Zion Station Units 1 and 2  
NRC Docket Nos. 50-295 and 50-304

Proposed Technical Specification Change  
to  
Appendix B, Environmental Technical Specifications

The following page has been revised:

Figure 2. Values of pH along the 9 meter depth contour in Lake Michigan, 1971 through 1978.

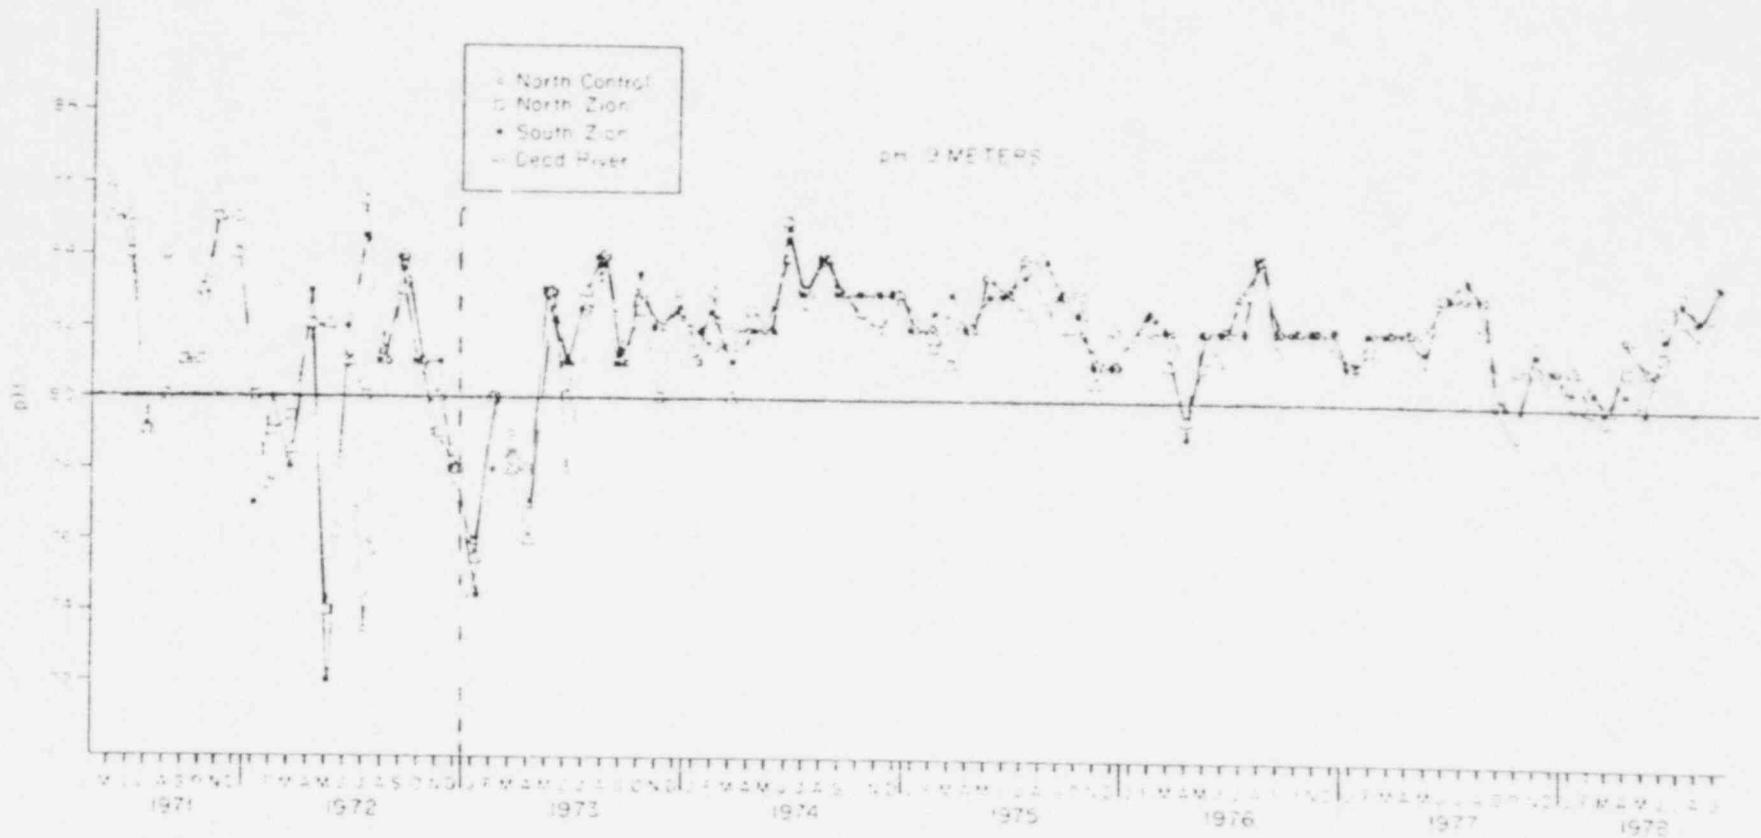
This conclusion is also supported by the field chemistry studies which were conducted in fulfillment of Appendix B requirements. As an example, Exhibit B summarizes the monthly pH measurements taken from May, 1971 through September, 1978, along the nine meter depth contour.<sup>2/</sup> This depth contour included two control transects (North and South Control) and two transects within the predicted area of thermal influence. As stated in the report, pH was more variable during 1971 and 1972 than in later studies. This was related to analytical variability and not to natural variability of Lake Michigan water. After 1972, the pH was consistently above 8.0.
